RQSC JUSTIFICATION REPORT

RQSC No.:	RQSC18Q-4038 - Issue 3 to Issue 4	Page 1 of 10 Pages
EDNS No.:	EDNS01001274063

RQSC18Q-4038 Issue 4 – Section 6.2.1:

Figure 6. Defect zones (All dimensions in mm).

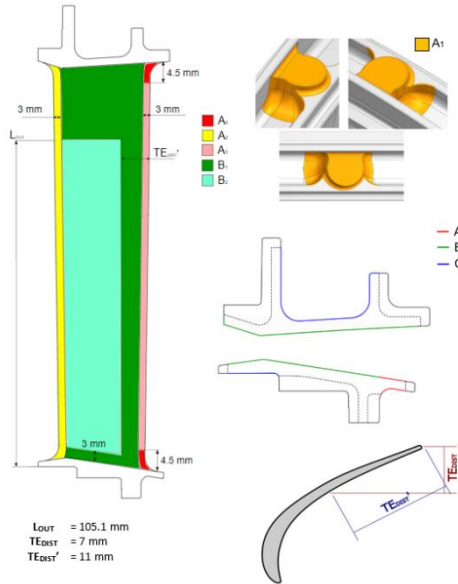
RQSC18Q-4038 Issue 3 – Section 6.2.1:

Zone	Depth	Extension	Feature	Remark	Remark 2
A0	None	None	TE & LE (3 mm) Rear inner platform (flowpath and no flowpath)	N/A	N/A
A1	0.4 mm	- Faired min 5X Depth, 6mm max - Separated 3X the max blend faired	Bosses	N/A	8 per cast
A2	0.381 mm deep or 25% of LST* whichever less	- Faired min 5X Depth, 8 mm max - Separated 3X the max blend faired	LE (3 mm) Under line defined	Maximum 6 per airfoil	24 per casting The combined total depth/thickness reduction of two blends aligned on opposite sides of pressure and suction surfaces may not exceed the allowance of a single blend.
B1	0.381 mm deep or 25% of LST* whichever less	- Faired min 5X Depth, 8 mm max - Separated 3X the max blend faired	Airfoil (suction and pressure surfaces including fillets as indicated) Platforms (washed surfaces)	Maximum 6 per airfoil.	Only one blend per fillet. Maximum 6 per airfoil (all B1 or 1xB2 + 5xB1) Maximum total number of blendings 24 per castings.

B2	0.75 mm deep or 50% of LST* whichever less	- Faired min 5X Depth, 8 mm max - Separated 3X the max blend faired	Airfoil (suction and pressure surfaces indicated)	Only one blend per airfoil.	The combined total depth / thickness reduction of two blends aligned on opposite sides of pressure and suction surfaces may not exceed the allowance of a single blend.
C	0.5 mm deep	- Faired min 5X Depth, 4 mm max - Separated 3X the max blend faired	None gas washed surfaces as indicated	No blendings aligned on opposite sides of inner platform (flowpath and no flowpath) surfaces are allowed.	The combined total depth/thickness reduction of two blends aligned (interaction of B and C zones) on opposite sides of mid outer platform (flowpath and no flowpath) surfaces may not exceed 0.5 mm.

Zone	Depth	Extension	Feature	Remark	Remark 2
A0	None	None	TE & LE (3 mm) Rear inner platform (flowpath and no flowpath)	N/A	N/A
A1	0.4 mm	- Faired min 5X Depth, 6mm max - Separated 3X the max blend faired	Bosses	N/A	8 per cast
A2	0.381 mm deep or 25% of LST* whichever less	- Faired min 5X Depth, 8 mm max - Separated 3X the max blend faired	LE (3 mm) Under line defined	Maximum 6 per airfoil	Maximum 6 per airfoil (either A2 and/or A3 combination) Maximum total number of blendings 24 per castings.
A3	0.5 mm deep or up to min wall 0.535 mm	- Faired min 5X Depth, 8 mm max - Separated 3X the max blend faired	TE (3 mm) Under line defined	Maximum 6 per airfoil	The combined total depth/thickness reduction of two blends aligned on opposite sides of pressure and suction surfaces may not exceed the allowance of a single blend.
B1	0.381 mm deep or 25% of LST* whichever less	- Faired min 5X Depth, 8 mm max - Separated 3X the max blend faired	Airfoil (suction and pressure surfaces including fillets as indicated) Platforms (washed surfaces)	Maximum 6 per airfoil.	Only one blend per fillet. Maximum 6 per airfoil (all B1 or 1xB2 + 5xB1) Maximum total number of blendings 24 per castings.

B2	0.75 mm deep or 50% of LST* whichever less	- Faired min 5X Depth, 8 mm max - Separated 3X the max blend faired	Airfoil (suction and pressure surfaces indicated)	Only one blend per airfoil.	The combined total depth / thickness reduction of two blends aligned on opposite sides of pressure and suction surfaces may not exceed the allowance of a single blend.
C	0.5 mm deep	- Faired min 5X Depth, 8 mm max - Separated 3X the max blend faired	None gas washed surfaces as indicated	No blendings aligned on opposite sides of inner platform (flowpath and no flowpath) surfaces may not exceed 0.5 mm	The combined total depth / thickness reduction of two blends aligned on opposite sides of pressure and suction surfaces may not exceed the allowance of a single blend.
